Town of Arlington, MA Redevelopment Board

Agenda & Meeting Notice November 7, 2022

3. Public Hearing Docket #3717 80 Broadway

Public Hearing Docket #3722 141 Massachusetts Avenue

③ WINTER 3PM

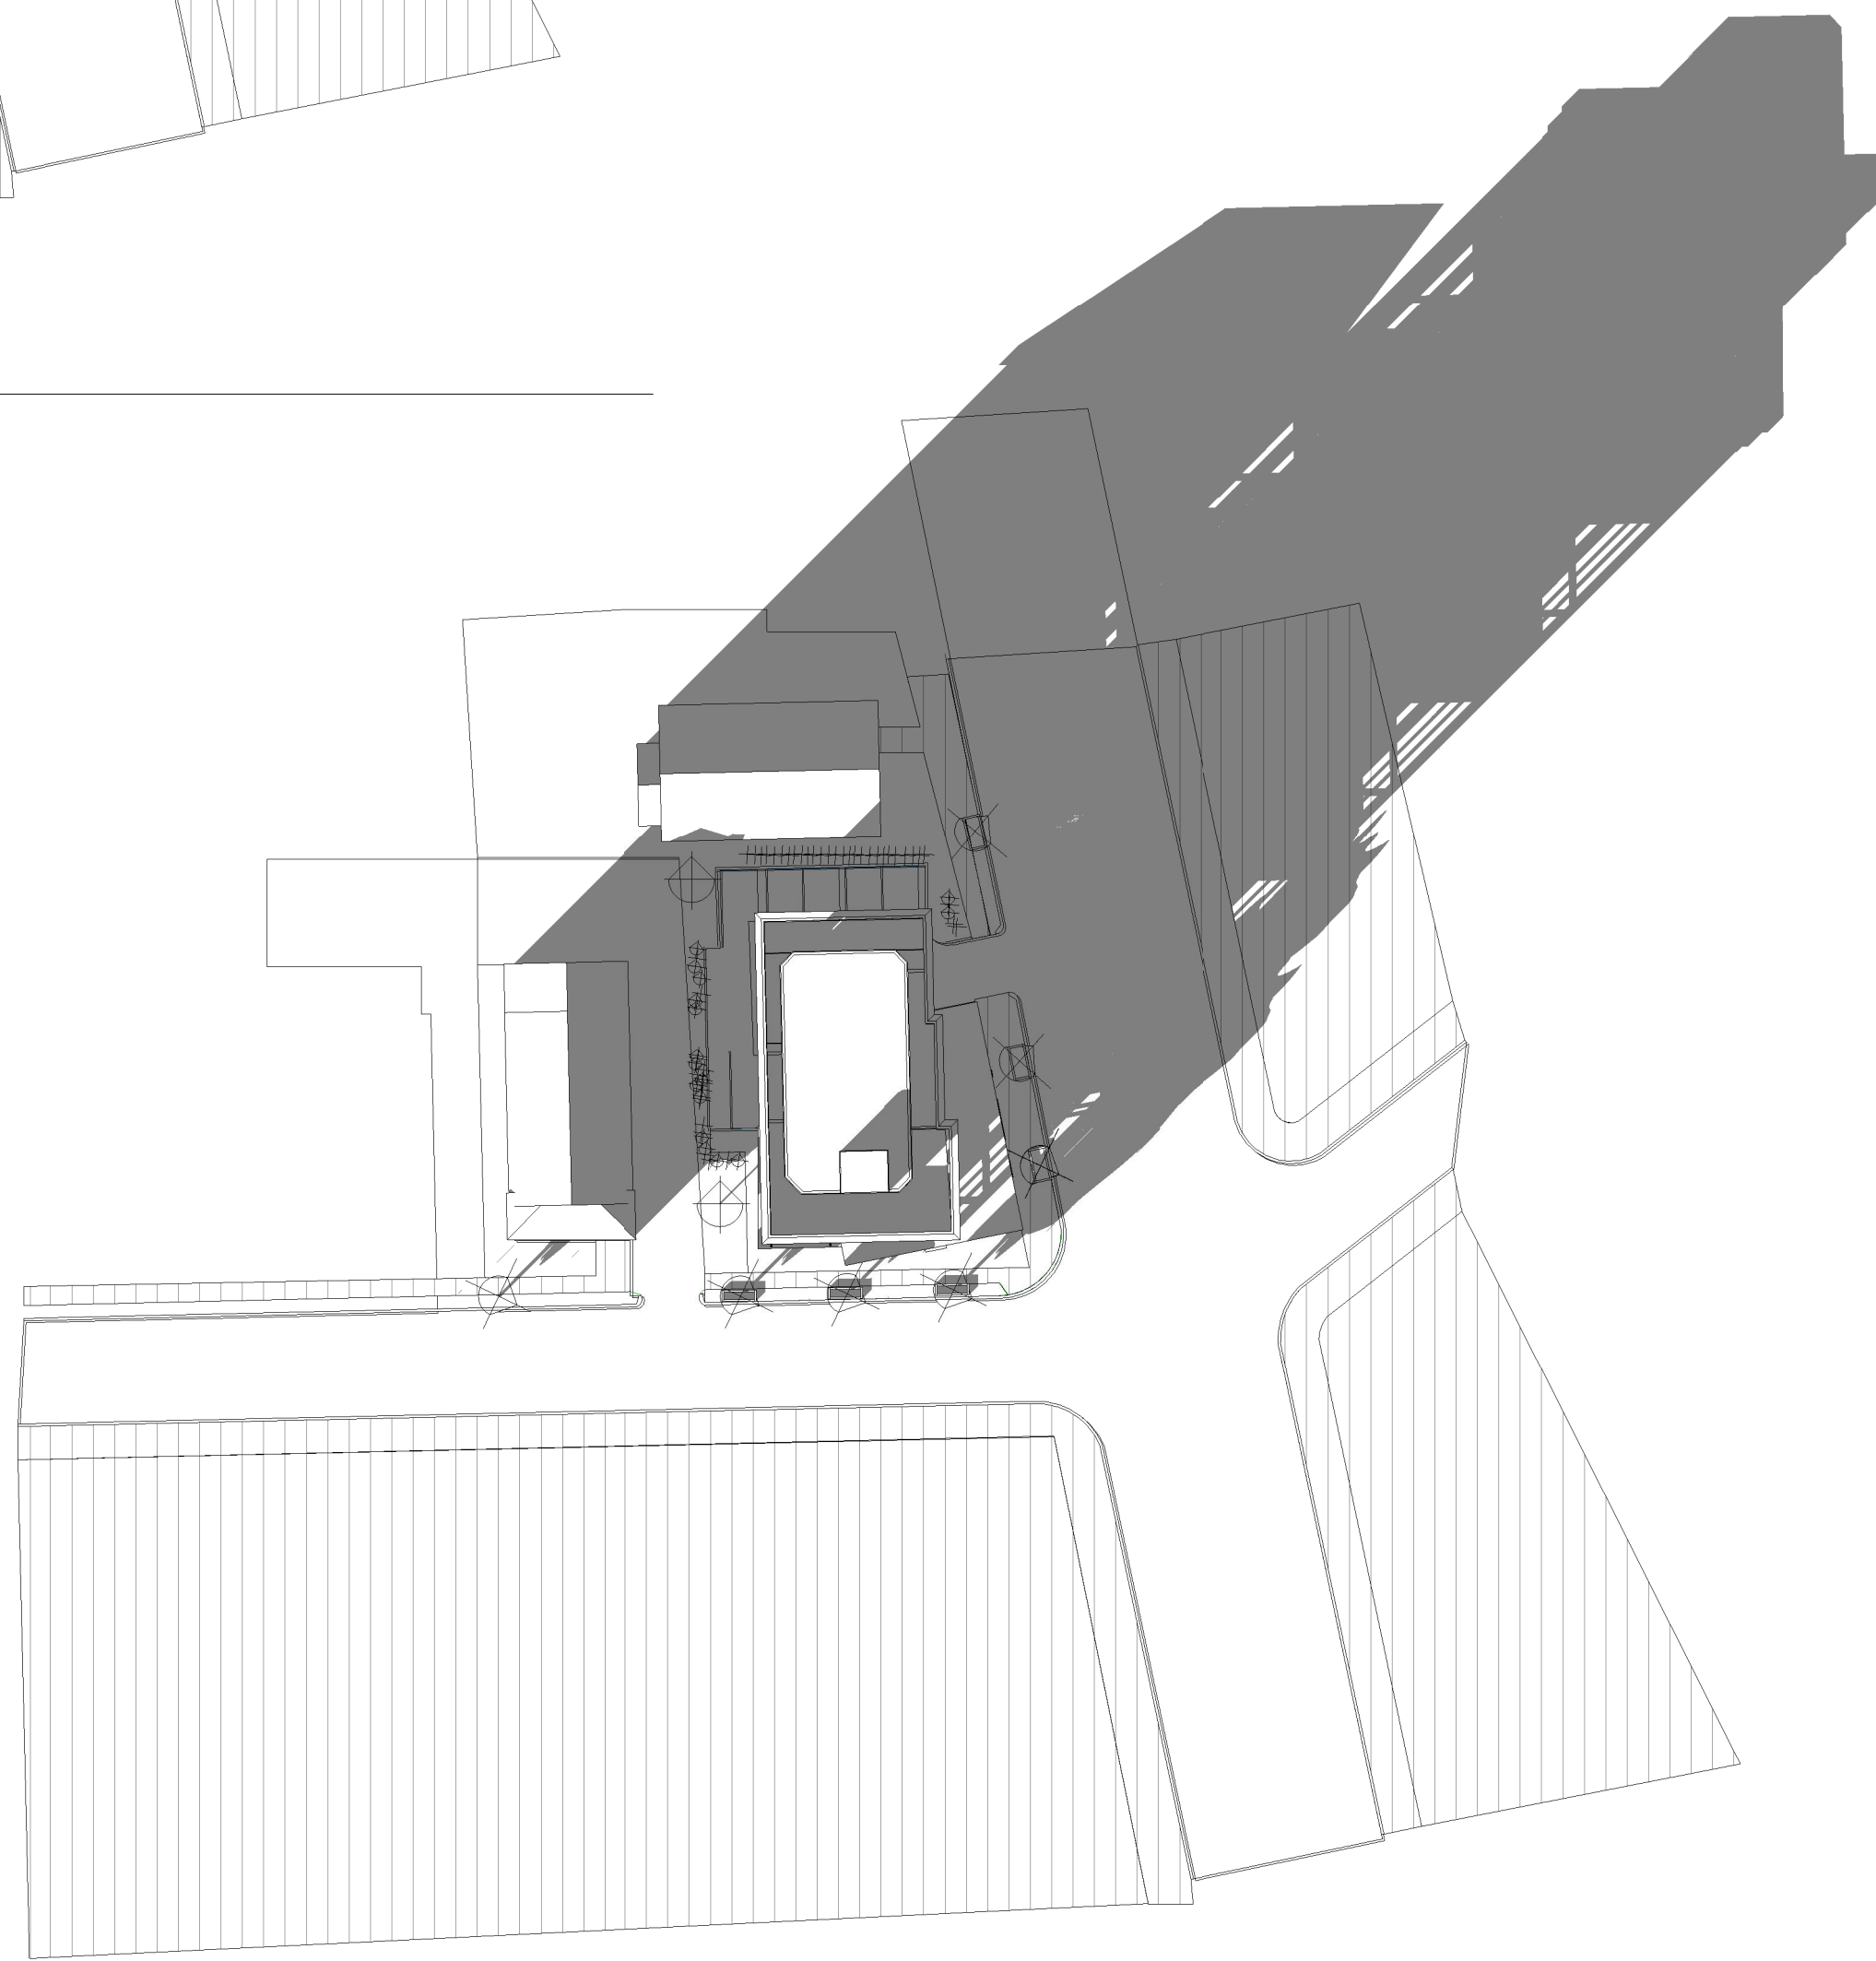
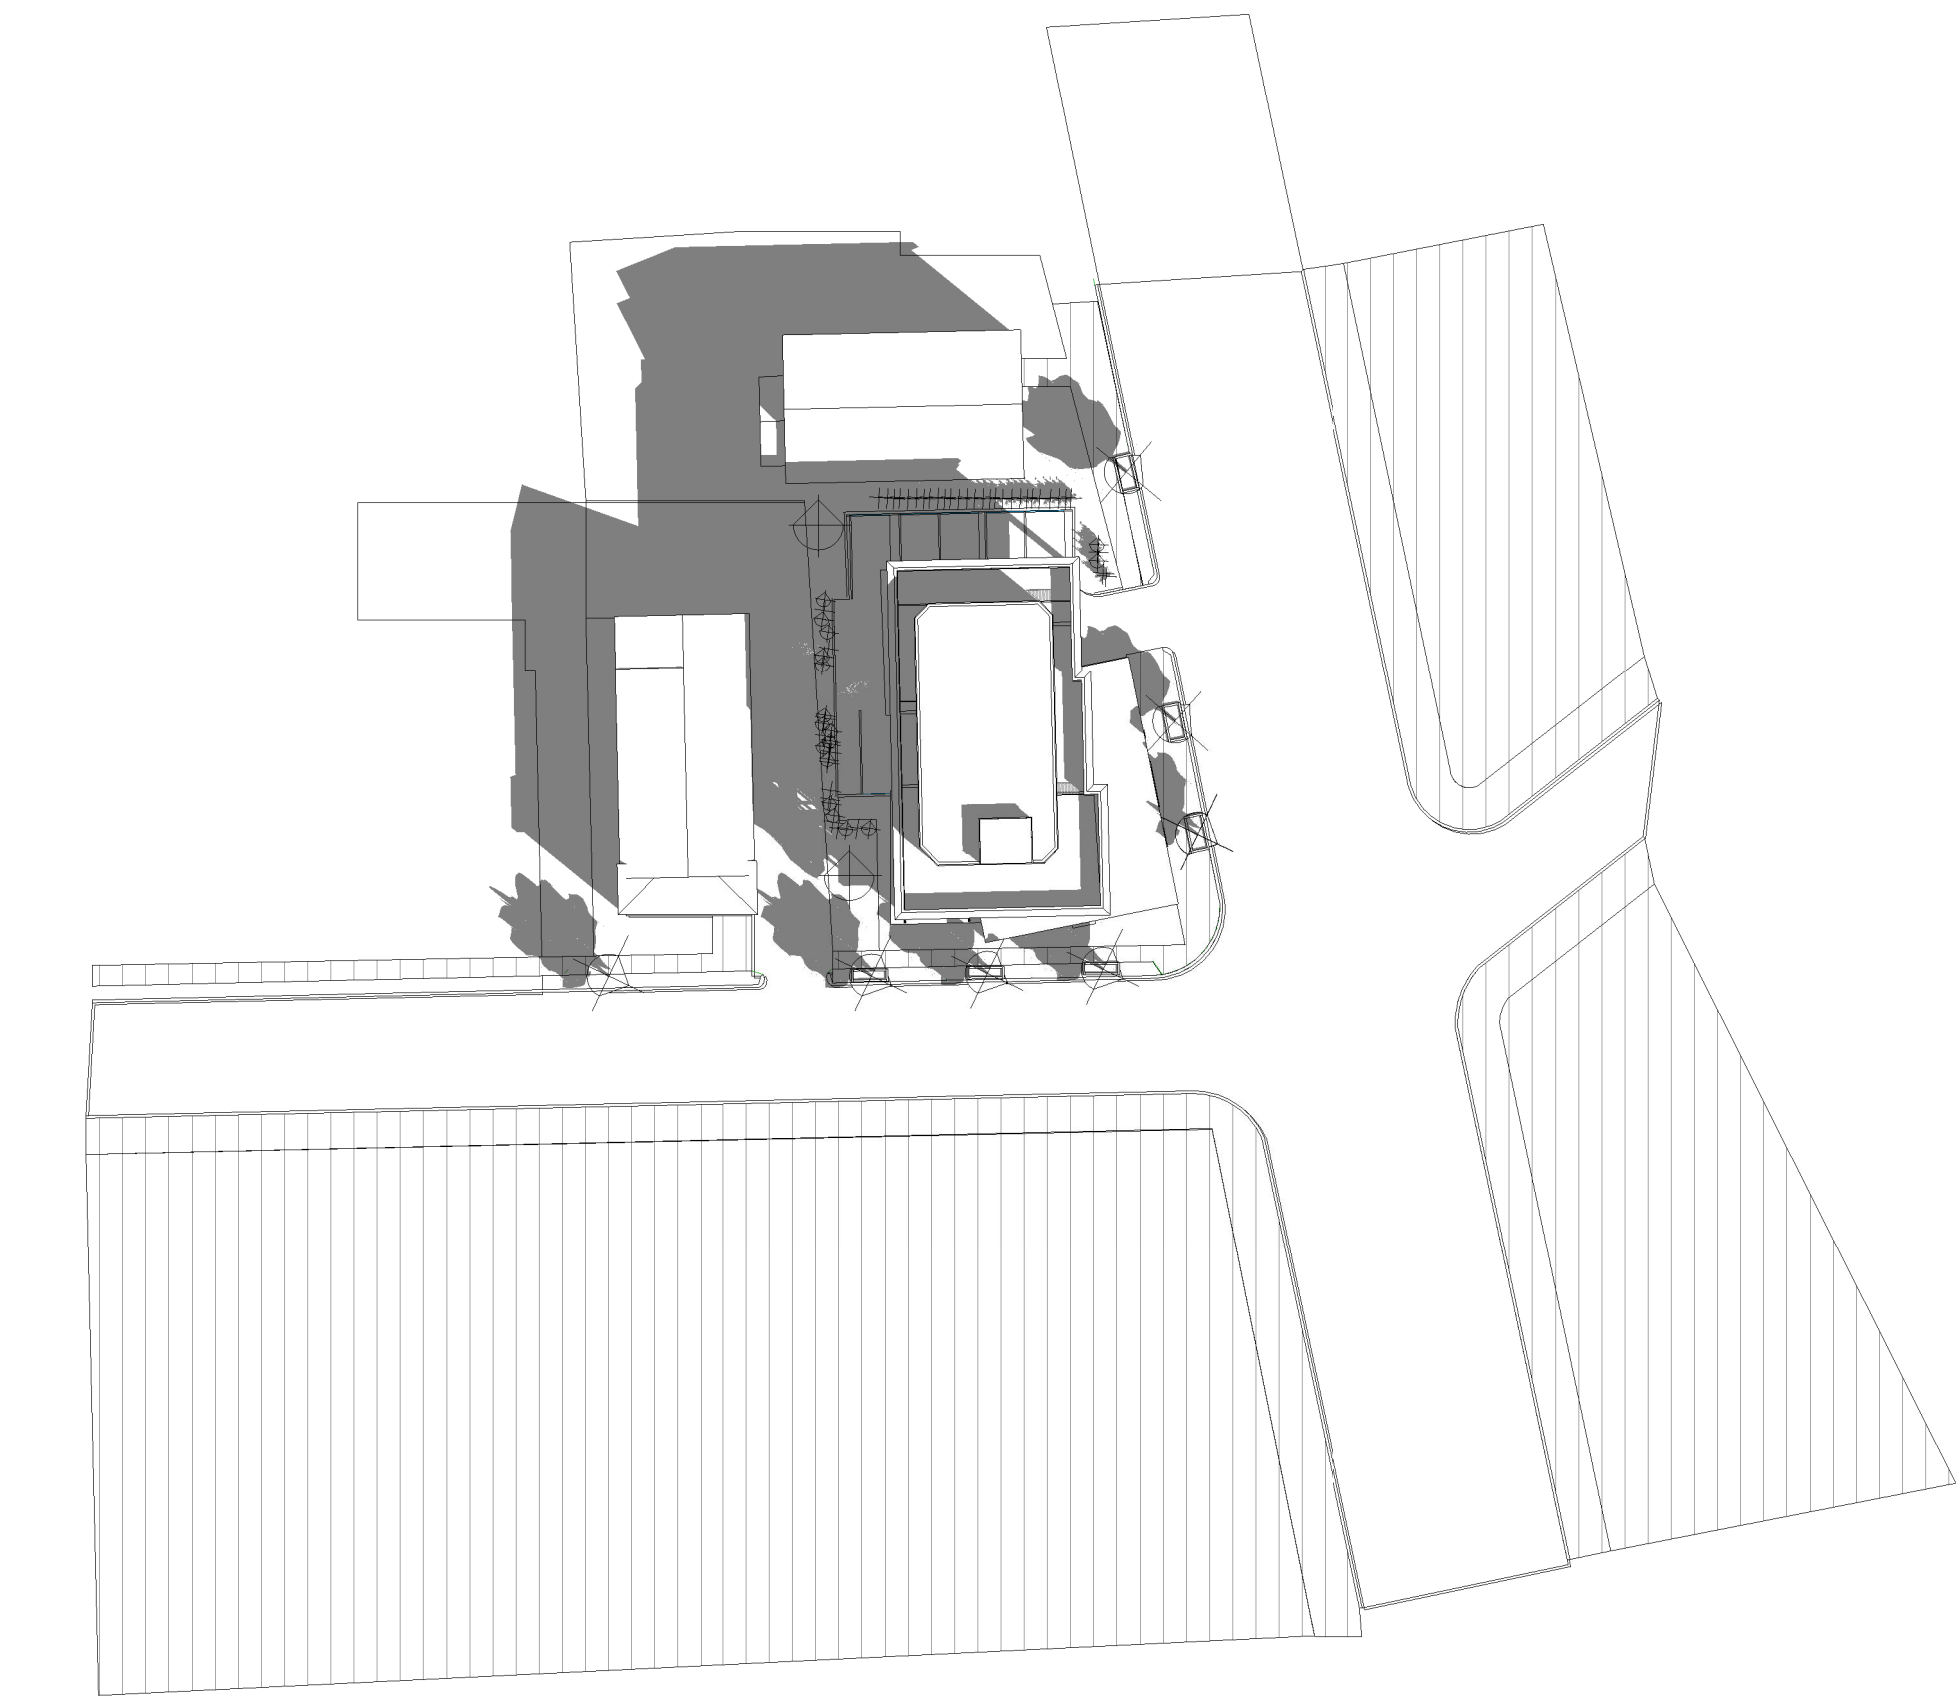
5. Could the applicant provide the Board with corrected and more detailed solar impact drawings A2.10 - A2.13? These drawings incorrectly show Broadway as running North to South, more than 60° off from reality. These drawings omit any detail of the affected properties, notably the array of solar panels on the roof of 88 Broadway.
